Southern California Edison
A.09-09-022 – Alberhill PTC & CPCN

DATA REQUEST SET CPUC - Supplemental Data Request - 009

Question DG-MISC-68:

Figure 1

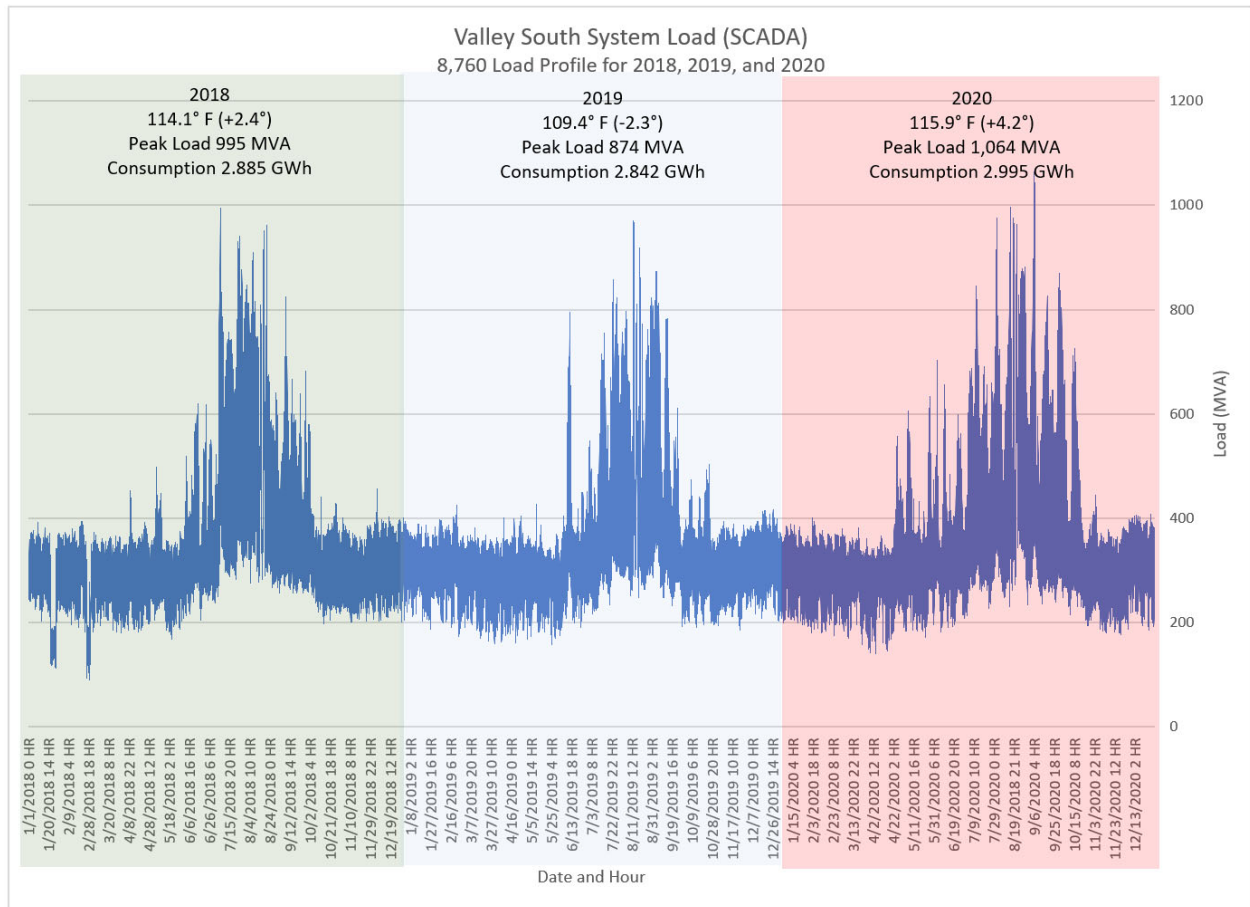
Is SCE using SCADA or AMI data to quantify COVID-19 impacts? If so, can you describe how? If not, can you explain why not and what alternative approach is being taken?

South System level to gain insight as to whether there were any obvious COVID-19 impacts on the overall system loads that were observable. SCE did not discern any. Please see the three graphics below. Figure 1 presents three years of 8,760 hourly demand data (for observation of an entire year) for the Valley South System for the years 2018-2020. Figure 2 presents hourly data but is focused only the four summer peaking months of June through September (for observation of the summer peak season) for the same years 2018-2020. Figure 3 presents hourly data but is focused only the single highest loading day of the year for the same years 2018-2020 (for observation of the daily load shape).

In 2020, the Valley South System peaked at its all-time highest loading value and highest energy consumption for a single year (surpassing 2018). However, SCE notes that 2020 was also a higher-than-normal peak temperature year and several degrees higher than 2018. In Figure 1 the recorded peak demand clearly appears in line with expectations given the temperature. In fact, preliminary analysis of SCE's forecast show that for 2020 the weather-adjusted peak value (reflecting the downward adjustment of the recorded peak to reflect what would be expected during a normal 1-in-2 year value) was within 1% of the projected value from SCE's last 10-year forecast (produced without the knowledge of the impending pandemic). Additionally, in Figure 1, the energy

consumption for all of 2020 was 3% higher than the average of the three years but SCE notes that the temperature was also 2.4% higher than the average of the three years. Figure 2 provides data focused on just the summer months and the performing the same comparison of energy consumption during 2020 yields an increase of 2.4% higher than the average of the three years (for the summer months) and this also correlates well with the higher-than-average temperature recorded in 2020 (2.4% higher than the average of the three years). Figure 3 provides data focused on the single highest peak day of each of the three years. Commonalities can be observed including the load shape, peak time, off-peak minimum loading, and energy consumption relative to temperature.
